Franklin County Planning Commission

Wednesday, September 11, 2013
1:30 pm

i. **ZON-13-04 – Anthony Hray**

Case ZON-13-04

SITE DEVELOPMENT PLAN
FOR
3180 VALLEY VIEW DRIVE
SNYDER MASONARY AND SUPPLIES

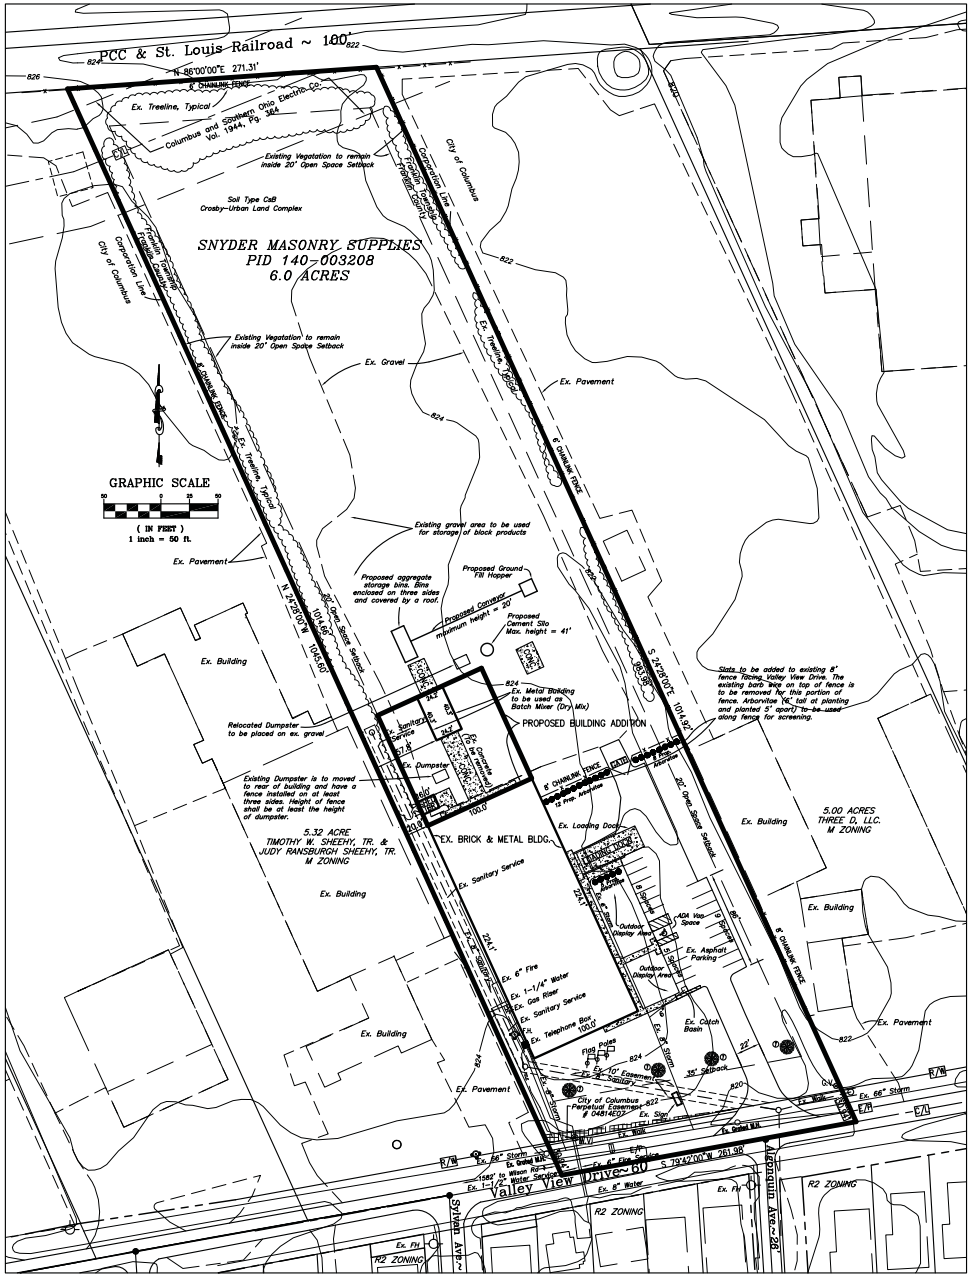
The site currently provides 22 paved (asphalt) parking spaces and one (1) paved (concrete) loading space. The parking and loading space layout is detailed on the development plan. Based on the number of full time employees (eight (8)) and the gross floor area of the industrial building occupied by each use, 36 parking spaces and four (3) loading spaces are required by code. Both the number of parking and loading spaces required increased as a result of the proposed building addition from 32 spaces and three (3) spaces respectively. The applicant received a waiver with their original request to relieve them of providing the parking and loading spaces initially required. The applicant is again requesting a waiver to relieve them of providing the additional parking and loading spaces required as a result of the building addition. Staff supports the request seeing as the proposed use of the building addition will not generate an increase in traffic or need for additional parking. The City of Columbus, Division of Planning and Operations, has posed no concerns with their request for a waiver from the parking and loading space requirements.

Stormwater from the existing industrial building and paved parking area is collected and discharged to an existing catch basin and storm sewer system. The aggregate material bins, ground hopper, silo, and conveyor system will be located to the rear of the industrial building and any associated runoff will be controlled and contained on site. Site topography and drainage details are provided on the development plan. The Franklin Soil and Water Conservation District and Franklin County Engineer's Office reviewed the stormwater drainage details of the previous rezoning request and posed no concerns.

Fencing
The site has an existing, non-conforming chain-link fence with barbed wire that surrounds the rear portion of the lot. The fence varies between six (6) and eight (8) feet in height and is detailed on the development plan. The applicant received a waiver to allow fencing in excess of six (6) feet in height and barbed wire to remain with their original request. No additional fencing is proposed.

approximately 1,200 square feet of green space; thus reducing the site's total green space from 2.92-acres to 2.89-acres. To help off-set the decrease in impervious surface, the applicant has agreed to install am above ground cistern to collect and re-use stormwater generated by the building addition. The outside production and storage area will be screened by adding slats to an existing eight (8) foot chain-link fence and planting six (6) foot arborvitae hedges so that the use is not visible from the public street. Six (6) foot arborvitae hedges will also be planted to help screen the existing loading space. The applicant will maintain an existing 20 foot landscaped easement along the entire perimeter of the tract in compliance with the PIP district requirements. All landscaping and screening improvements previously approved are detailed on the development plan. No additional screening or landscaping is required as a result of the request.

1. The applicant shall apply for and receive an approved Certificate of Zoning Compliance from the Franklin County Economic Development and Planning Department.

2. The applicant shall obtain all required permits and inspections from the Franklin Township Building Department, Franklin Township Fire Department, and City of Columbus Public Utilities Department prior to beginning construction and/or occupying the site.

3. The applicant shall install fencing, to the height of the existing dumpster, on at least three sides, to provide adequate screening and to prevent trash or debris from blowing onto adjacent properties.

4. The applicant shall install all landscaping and screening as required under rezoning case ZON-13-01.
5. The applicant shall consult with the Franklin Soil and Water Conservation District, Franklin County Engineer's Office, and Franklin Township Building Department on the design and installation of the above ground cistern and roof drainage system. The cistern shall be located to the side or rear of the building addition and shall be screened so that it is not visible from the public right-of-way. The development plan must be updated to include the location of the above ground cistern prior to the issuance of a Certificate of Zoning Compliance.
